ADDENDUM #02
TO
INVITATION TO BID #01

March 14, 2018

WESTERN CONNECTICUT STATE UNIVERSITY
RENOVATIONS TO
HIGGINS HALL & HIGGINS ANNEX

STATE PROJECT NO: BI-RD-290-CMR

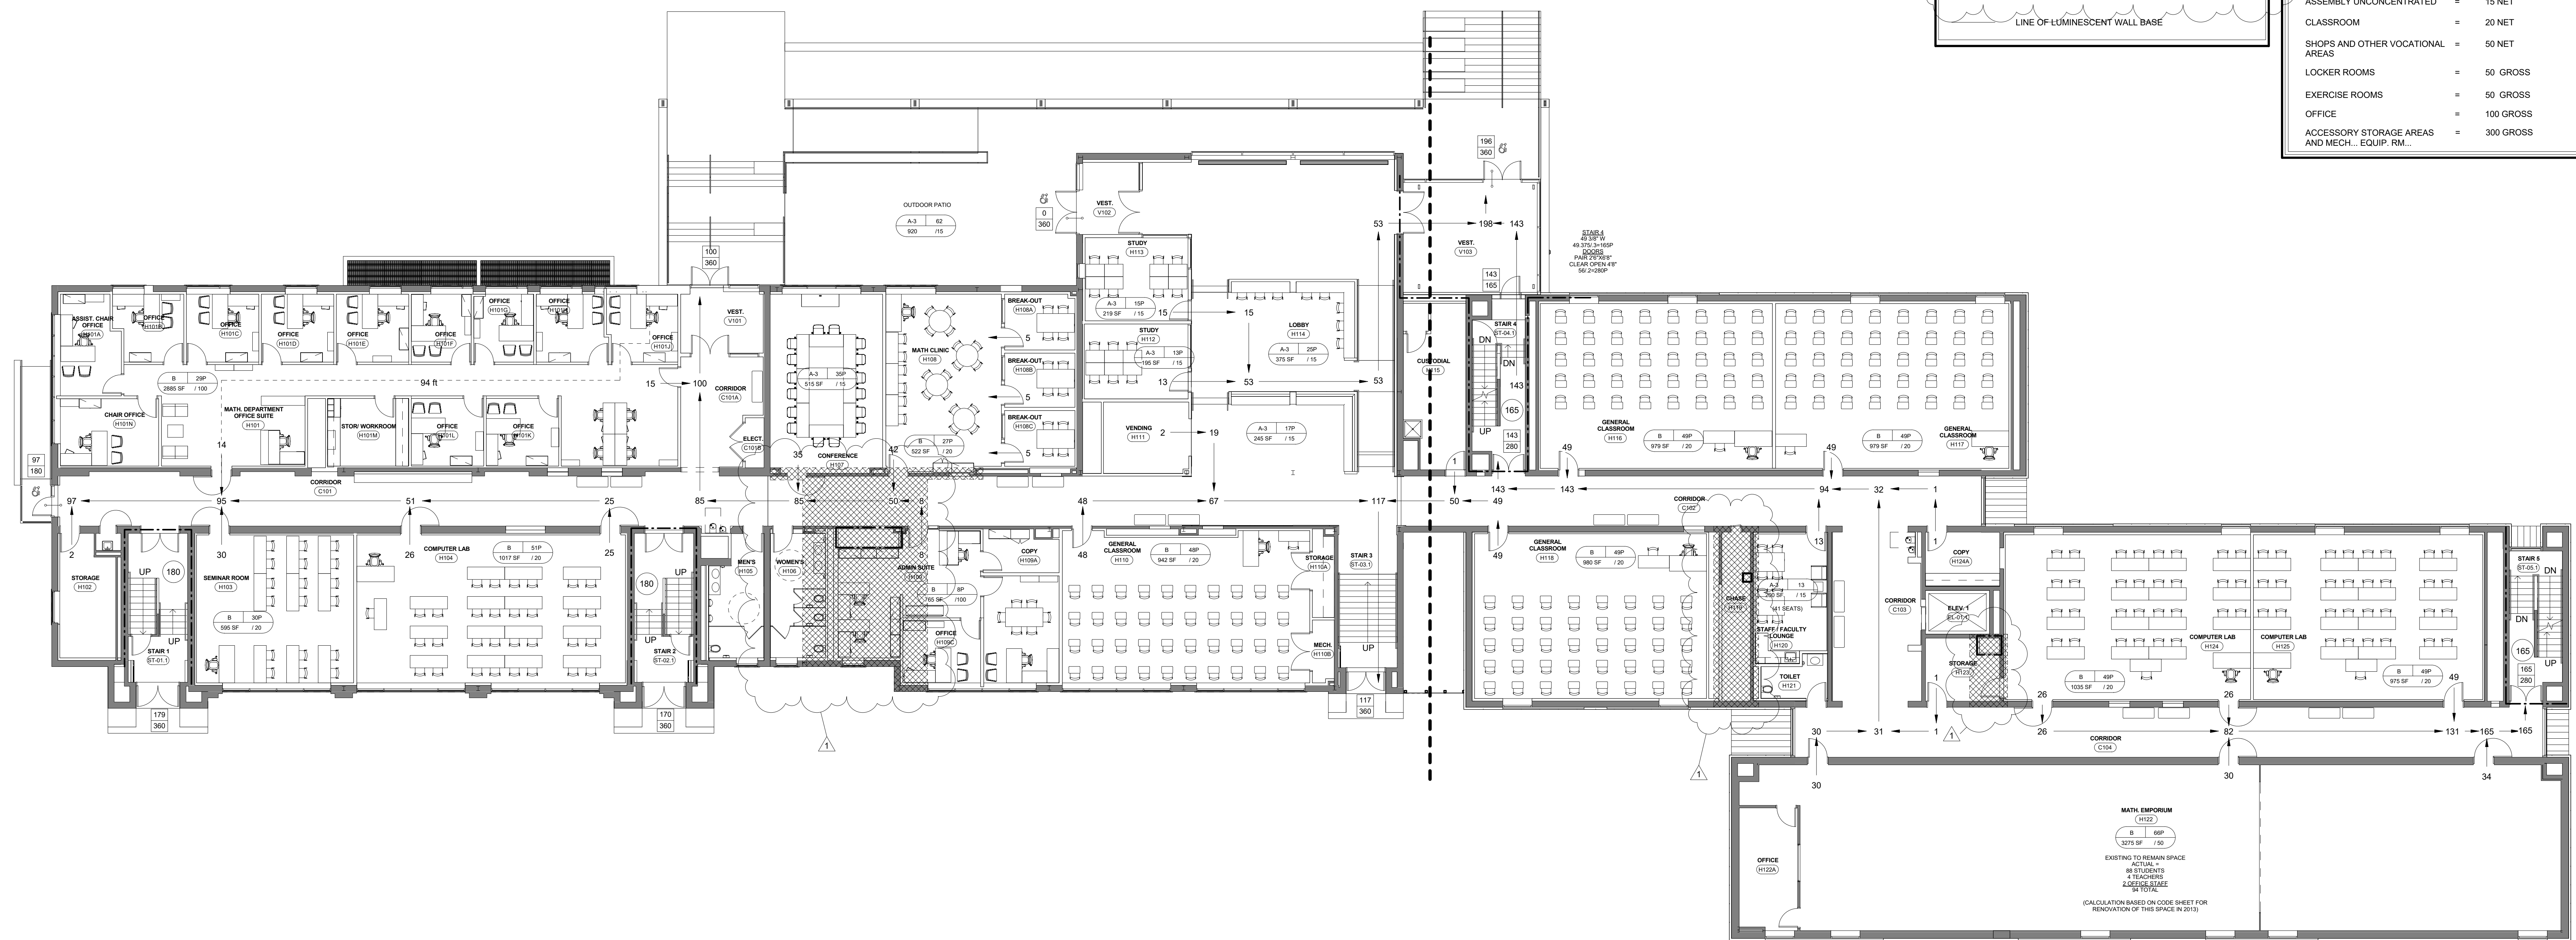
- RFI Question** – Where is Sprayed Fire Resistive Material (CAFCO) located on job?
- Answer* – Please refer to attached revised egress plans and fire stopping detail sheet showing the extent of spray fireproofing. This work is being re-assigned to the **BP #9.1 – Drywall and Carpentry Contractor**.

Refer to TSKP Supplement #1 revised egress plans included with this addendum regarding scope.

scale: As indicated
drawn by: [Signature]
approved by: [Signature]
drawing no. **A2.21**

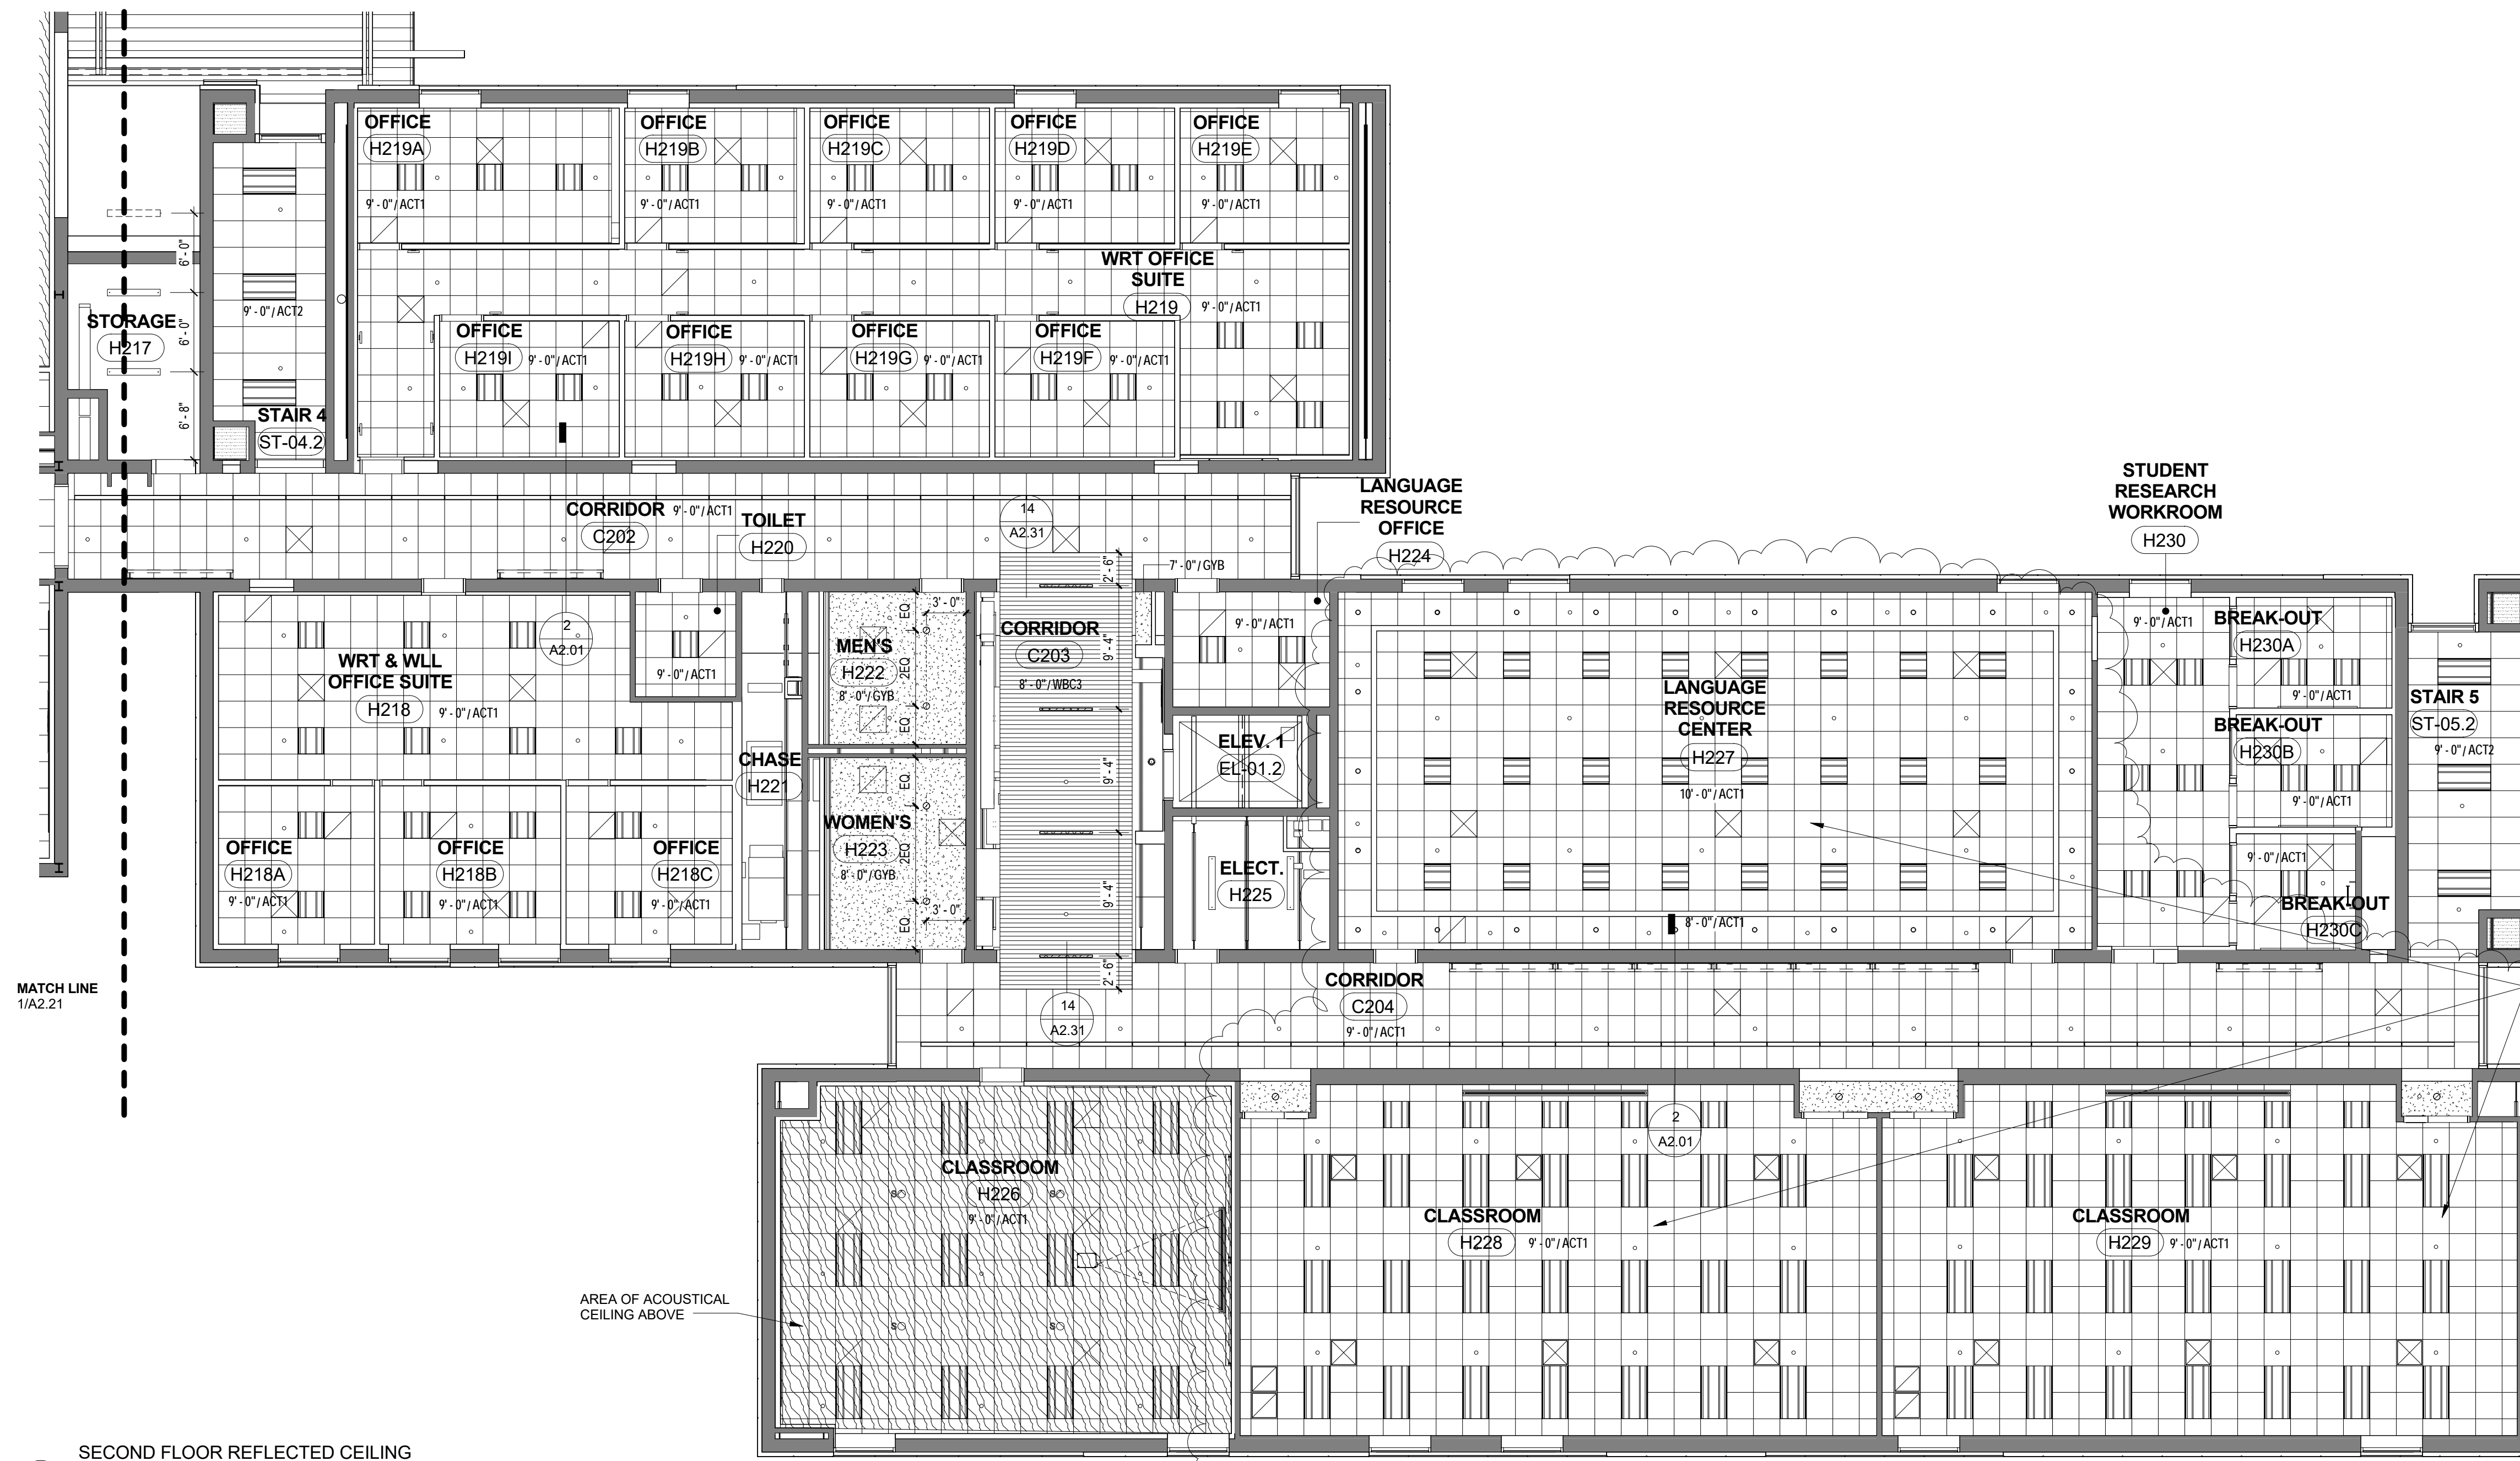
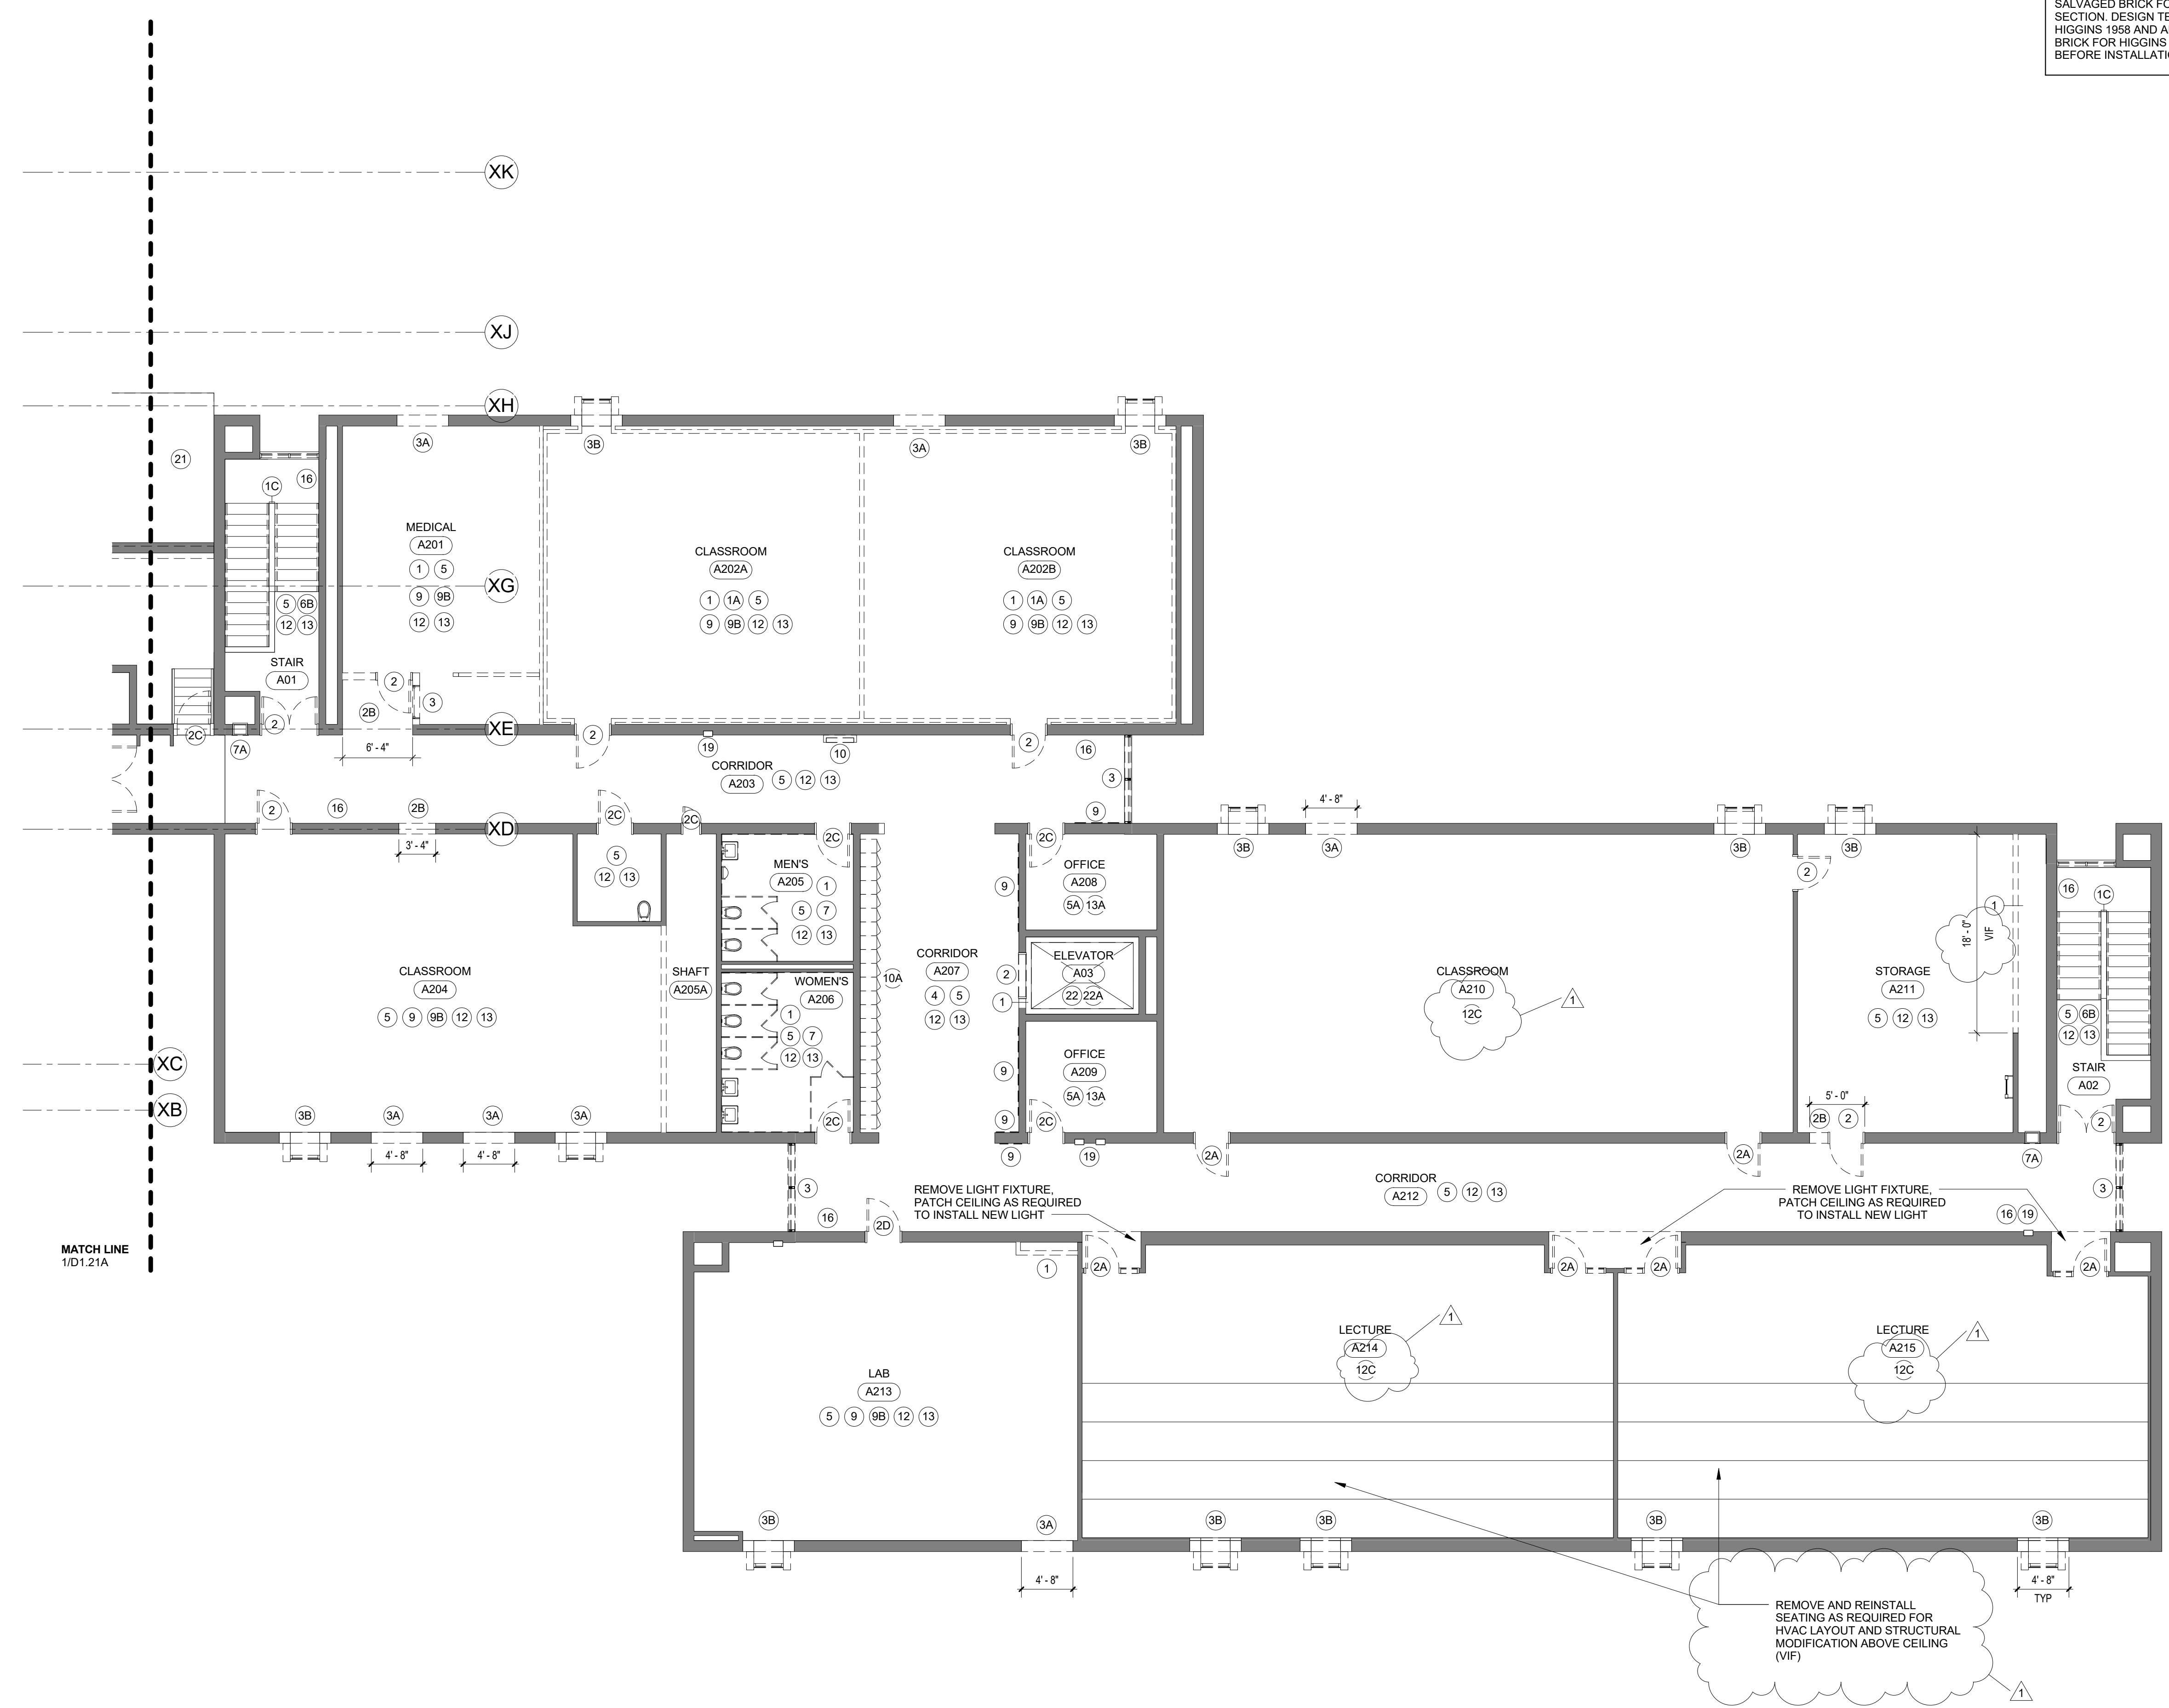
8. Replace abbreviation AWB on drawings with AVB which abbreviates Air Vapor Barrier.
9. Replace existing expansion joint and cover located on corridor walls and floors with new one at all floor levels between 1949 and 1958 addition. Refer to new spec section 079500.
10. A0.04:
- Replace drawing with revised A0.04.
11. A0.05:
- Replace drawing with revised A0.05.
12. A0.06:
- Replace drawing with revised A0.06.
13. A0.07:
- Replace drawing with revised A0.07.
14. A1.31A:
- Replace drawing with revised A1.31A.
15. A1.31B: Refer to A1.31A for updated roofing legend and added roofing notes.
16. A2.21:
- Replace drawing with revised A2.21.
